Draft changes to clause 95 including
TxVEC – rev2
(post June 5th ad hoc)

MMF ad hoc working document

Figure 95–3—TxVEC conformance test block diagram

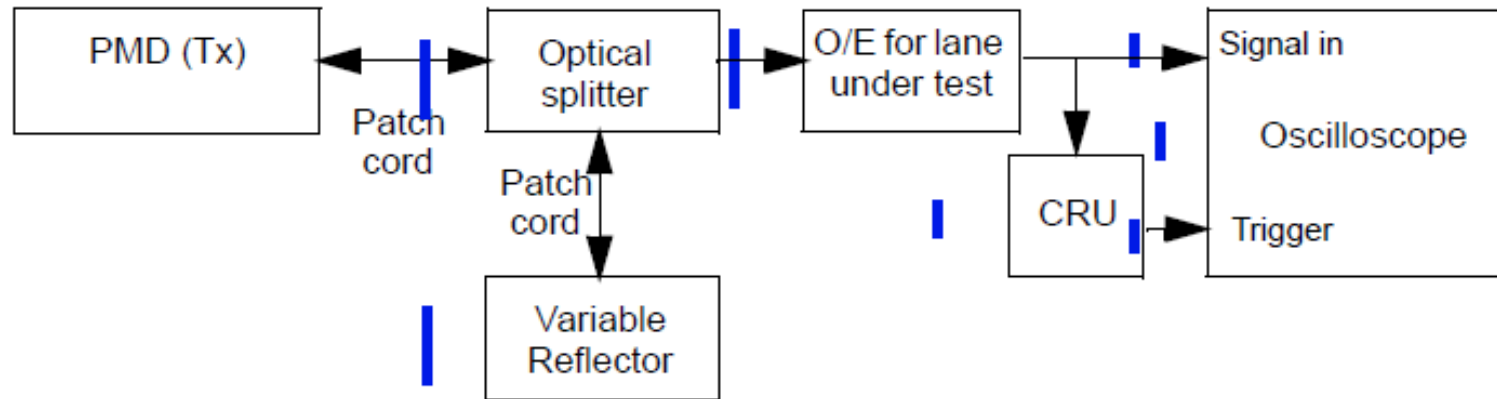
New section 95.8.5.1 test set up

A block diagram for the TxVEC conformance test is shown in Figure 95–3. Other measurement

Each optical lane is tested individually with all other lanes in operation. The optical splitter and variable reflector are adjusted so that each transmitter is tested with an optical return loss of 12 dB.

The combination of the O/E and the oscilloscope used to measure the optical waveform has a fourth-order Bessel-Thomson filter response with a bandwidth of 12.6 GHz. Compensation may be made for any deviation from an ideal fourth-order Bessel-Thomson response.

The clock recovery unit (CRU) has a corner frequency of 10 MHz and a slope of 20 dB/decade.

Figure 95-4—Illustration of the TxVEC measurement

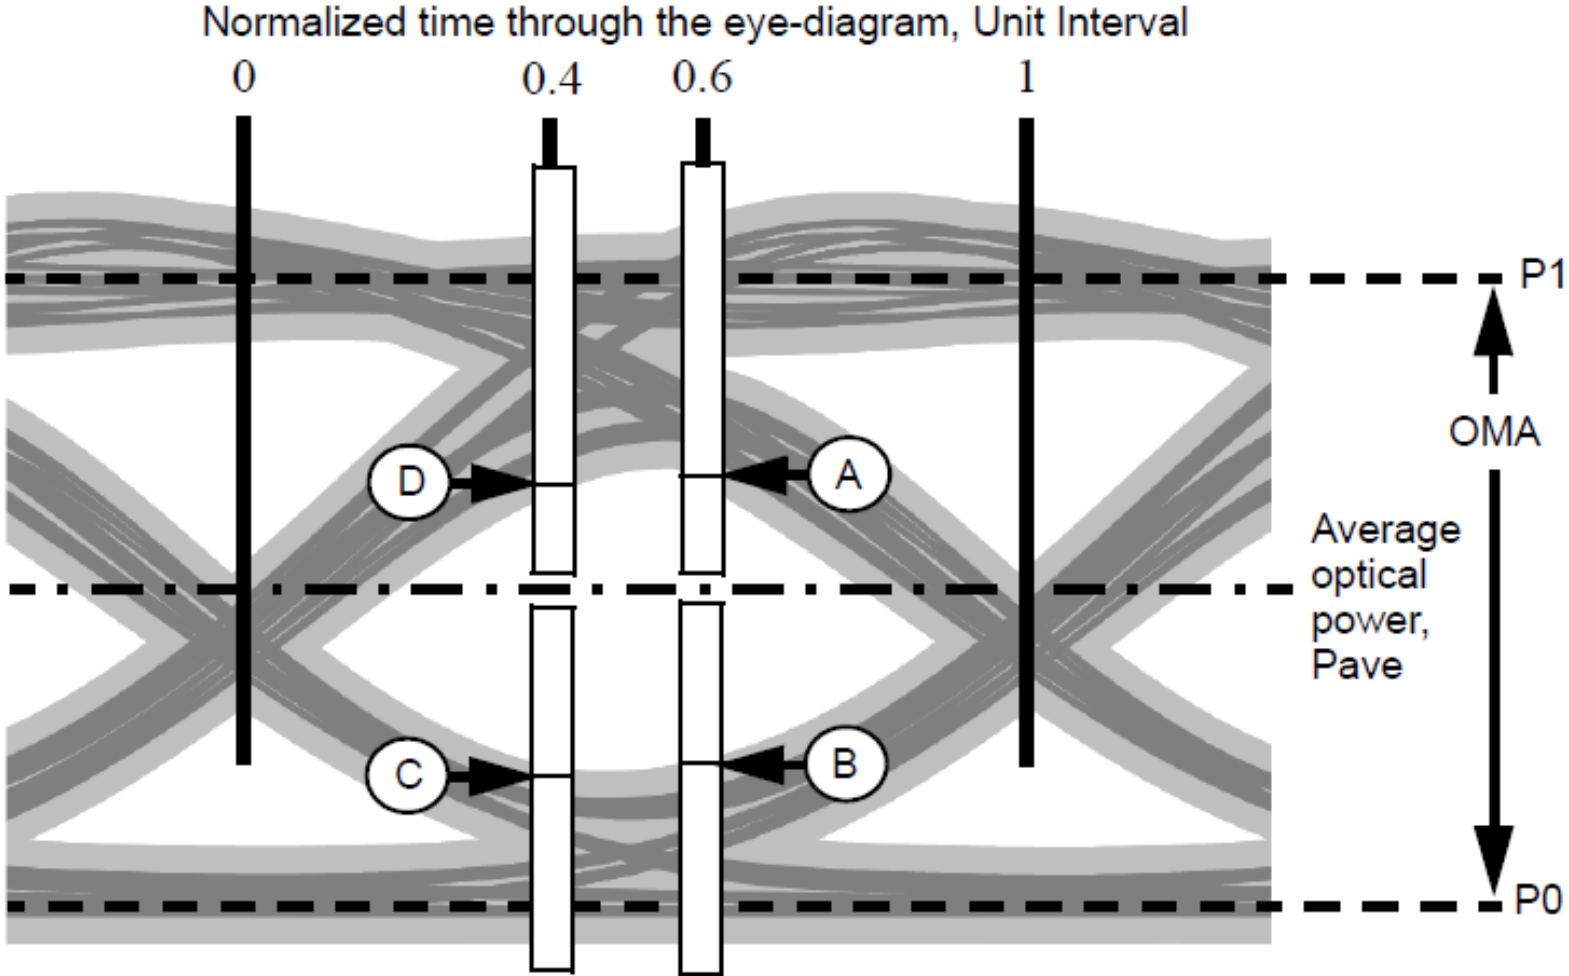
The oscilloscope is set up to accumulate samples for the optical eye-diagram of the transmitter under test, as illustrated in Figure 95–4.

The 0 UI and 1 UI crossing points are determined by the time average of the eye crossing points, as measured at the average optical power level, as illustrated in Figure 95–4.

Four vertical histograms are measured through the eye, centered at 0.4 UI and 0.6 UI, and above and below the average optical power of the eye-diagram, as illustrated in Figure 95–4.

Each histogram has a width of 0.04 UI. Each histogram window has one height boundary set close to average power level of the eye-diagram, and the other height boundary is set beyond the outer-most samples of the eye, so that no further eye samples would be captured by increasing the outer boundary of the histogram. Starting from the boundary of the histogram closest to the average optical power level, the optical power at which the cumulative distribution of each histogram equals the 0.005th percentile of the total number of samples for each histogram is recorded (these are the powers A, B, C, and D illustrated in Figure 95–4).

TxVEC is defined as the largest of the four quantities given by Equation (95–1) to Equation (95–4):

$$TxVEC(A) = 10\log_{10}\left(\frac{P1 - Pave}{A - Pave}\right) \quad (95-1)$$

$$TxVEC(B) = 10\log_{10}\left(\frac{Pave - P0}{Pave - B}\right) \quad (95-2)$$

$$TxVEC(C) = 10\log_{10}\left(\frac{Pave - P0}{Pave - C}\right) \quad (95-3)$$

$$TxVEC(D) = 10\log_{10}\left(\frac{P1 - Pave}{D - Pave}\right) \quad (95-4)$$

<i>Pave</i>	is the average optical power of the eye-diagram
<i>P0, P1</i>	are the optical one and optical zero levels of the eye-diagram
<i>A, B, C, D</i>	are the 0.005th percentile optical power levels of the four vertical histograms described in 95.8.5.2.
